1 July 2025

Our Ref: 240065-M
Reissue of: 240065-J

Geotechnical Response to Council Queries Delmore Residential Development

Group	Section R Proposed GL, Remedials, Loads (R-L)	Scenario	Normal (Measured GW)
Drawn By	RS	Company	Riley Consultants Ltd
Date	10/12/2024	File Name	Section R - June 2025.slm

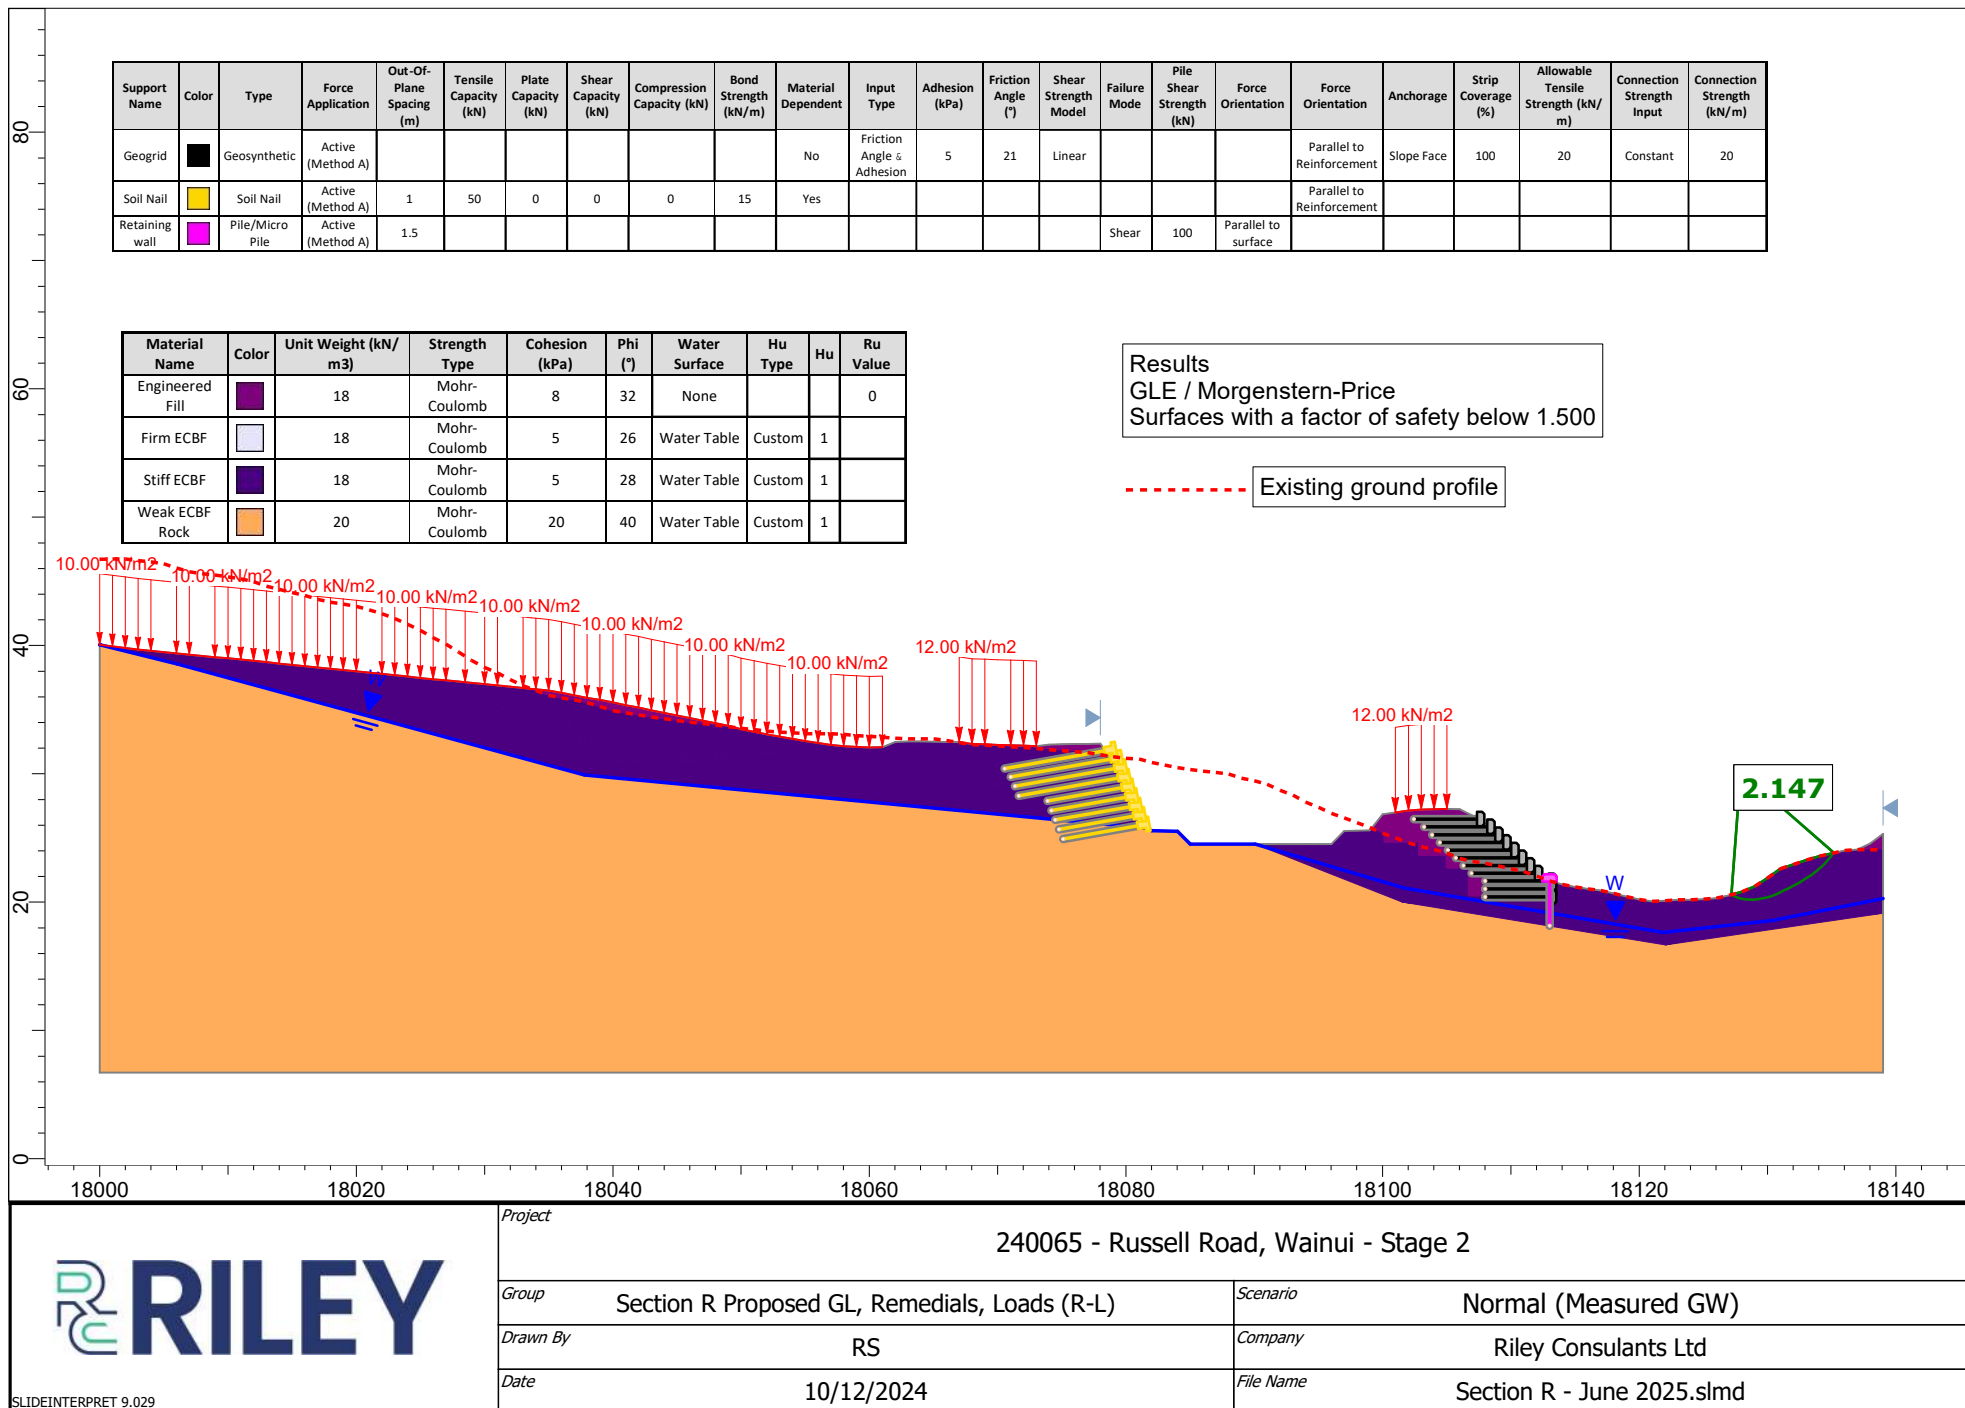
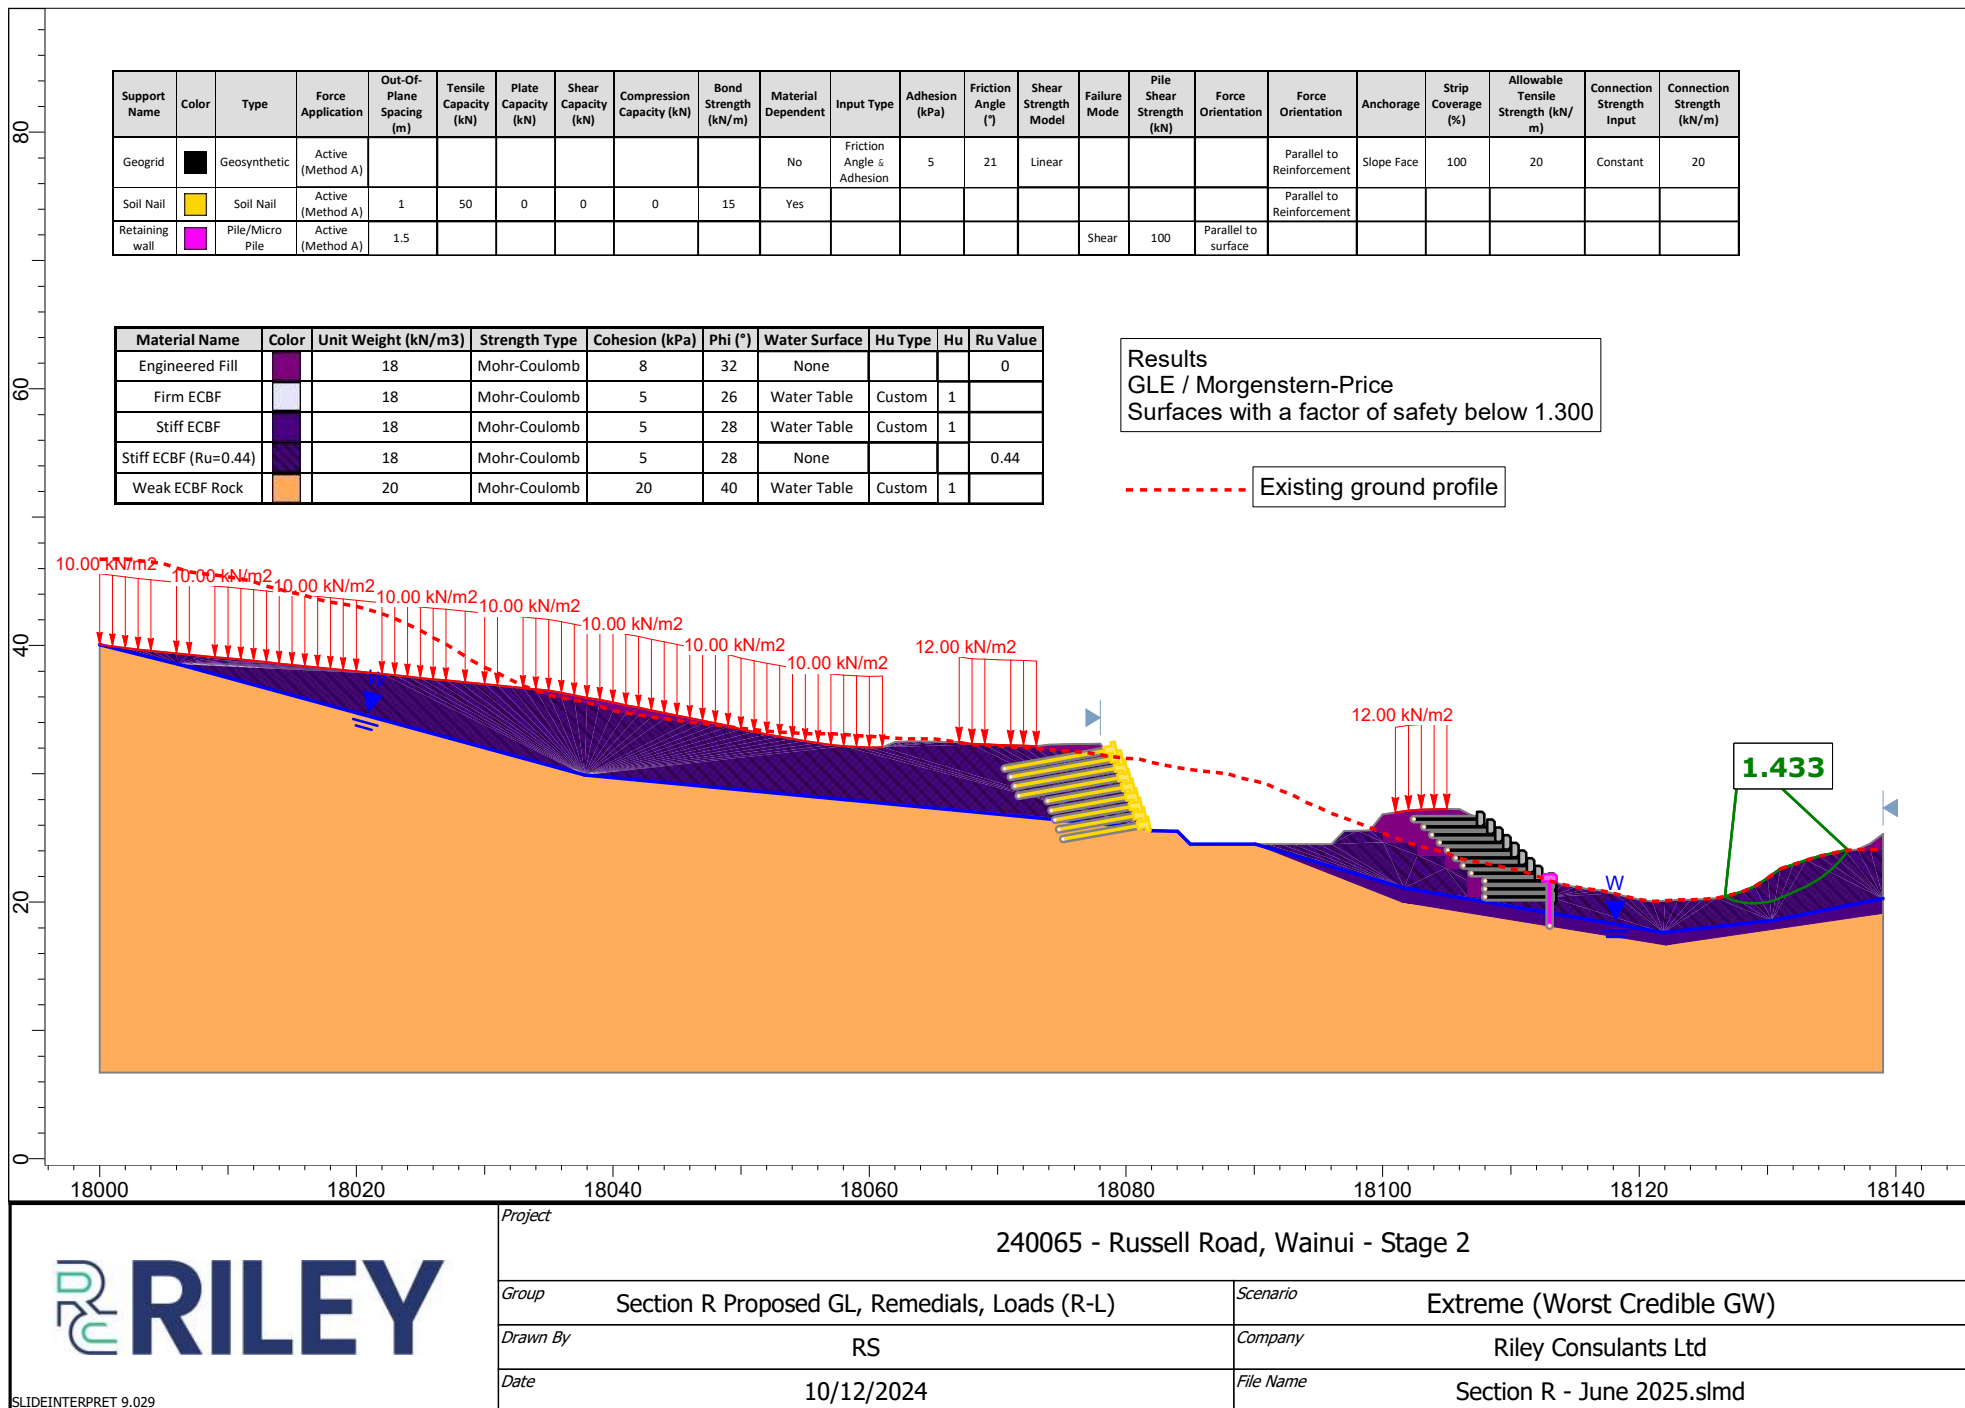
It would be beneficial to provide a stability analysis for Section R, considering potential theoretical slip surfaces from right to left to capture the other side of the MSE slope and palisade wall.

We have undertaken further analysis on Section R in a right-to-left direction with the post-development surcharges included in our response to Query (9) above. The results indicate that FoS values for the small section of the slope with a right-to-left aspect has acceptable FoS values in line with the CoP. Slope stability outputs are included in the appendix pertaining to the Query (9) response.

Project				240065 - Russell Road, Wainui - Stage 2			
Group		Section V - Proposed GL, Remedials, Loads (L-R)			Scenario		
Drawn By		JJW			Company		
Date		10/12/2024			File Name		
					Riley Consultants Ltd		
					Section V - June 2025.slm

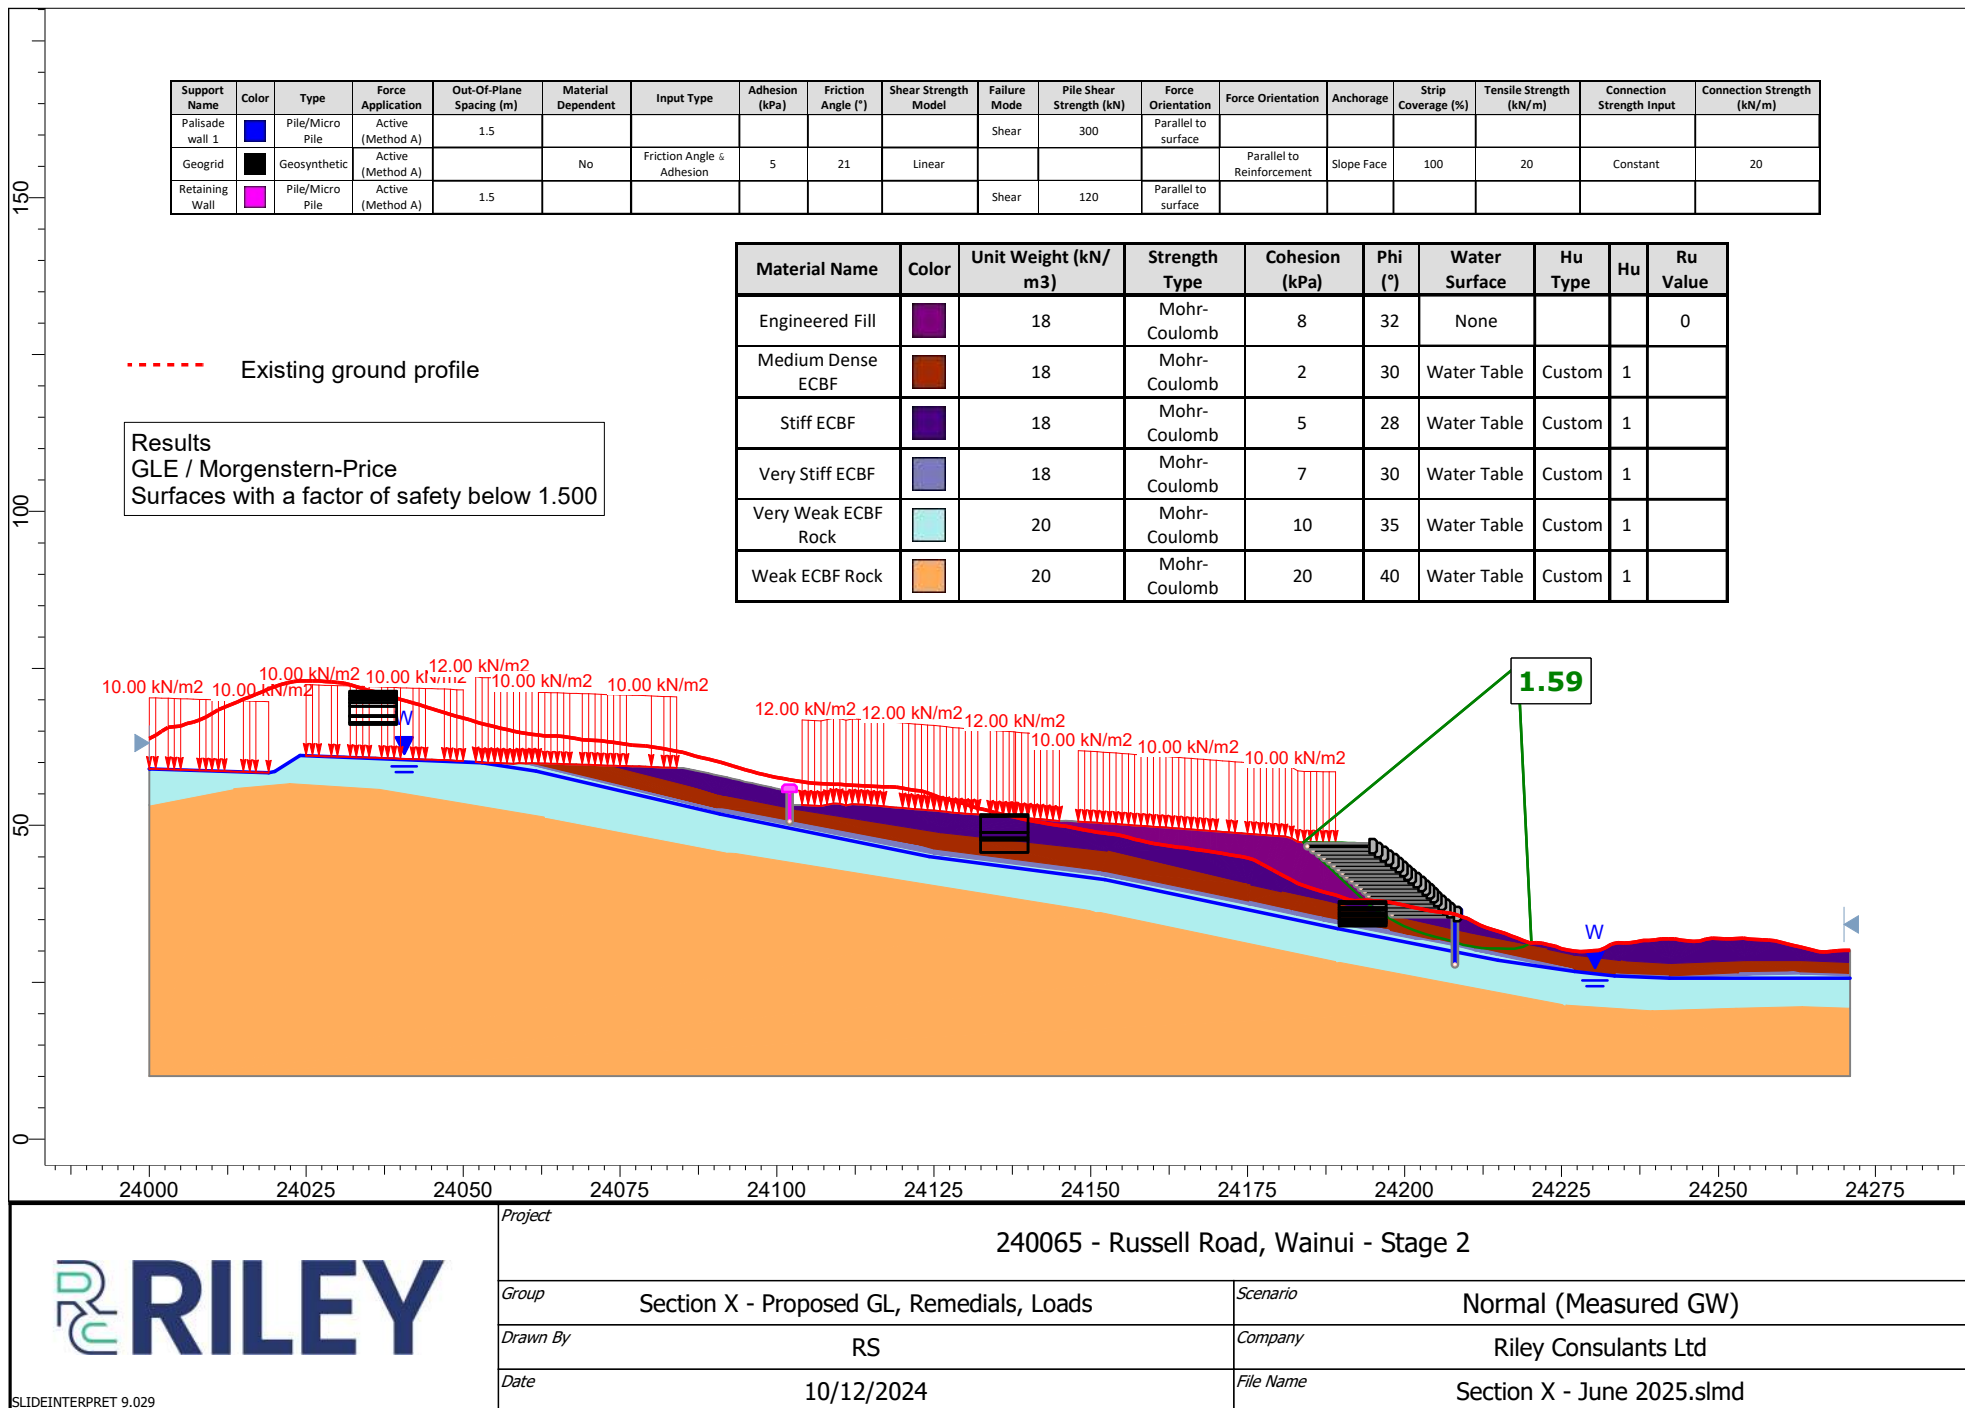
Soil parameters presented in Table 7 does not align with modelled parameters (e.g. unit weight of Medium Dense ECBF in table is 18 kN/m³ but in the Proposed GL (RHS) – Section V for Stage 2 seismic is 20 kN/m³). Discrepancies should be justified or revised.

This discrepancy was a typographical error in the original stability inputs. The unit weight of the medium dense ECBF material has been corrected in the reanalysis of Section V, with the slope stability outputs included in the slope stability appendix pertaining to the Query (9) response.
